Title: Advisory Committee on Reactor Safeguards
Fuels, Materials and Structures Subcommittee
Open Session

Date: Thursday, August 24, 2023

During today's meeting, the subcommittee will review the NRC's staff safety evaluation for approving PWROG's hydrogen-based transient cladding strain limit topic report. The subcommittee will hear presentations by and hold discussions with the NRC

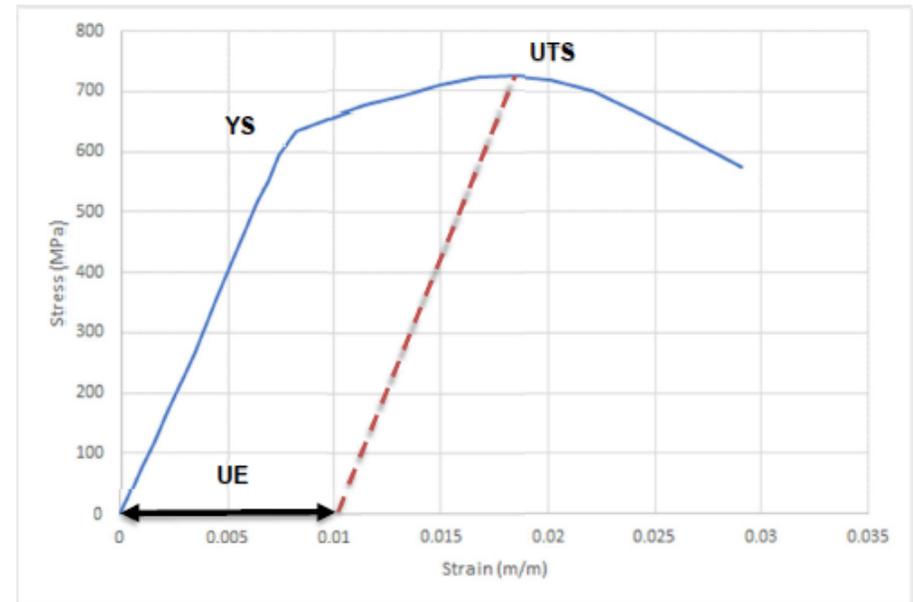
13 MEMBER MARCH-LEUBA: Pardon me, just for
14 my education. When we look at all the top materials,
15 you know (unintelligible) like Dr. Ballinger. When
16 you said percent, I see that the units are -- it's
17 percent units per meter? What is the one percent?

21 MEMBER MARCH-LEUBA: And you go back to
22 the previous slide. So in -- doesn't this .01 in the
23 excess scale, there is one percent?

18 MR. CREDE: It's percent increase of the
19 cladding diameter. So we take the ratio of the pre-
20 transient and the post-transient cladding diameter.

24 MR. CREDE: Yes.

1 MR. CREDE: And this is just a generic
2 figure. The numbers are just what I put into Excel to
3 make it plot, just to show what it looks like. These
4 are not specific to any actuals here. But yes, this
5 would be the one percent strain.
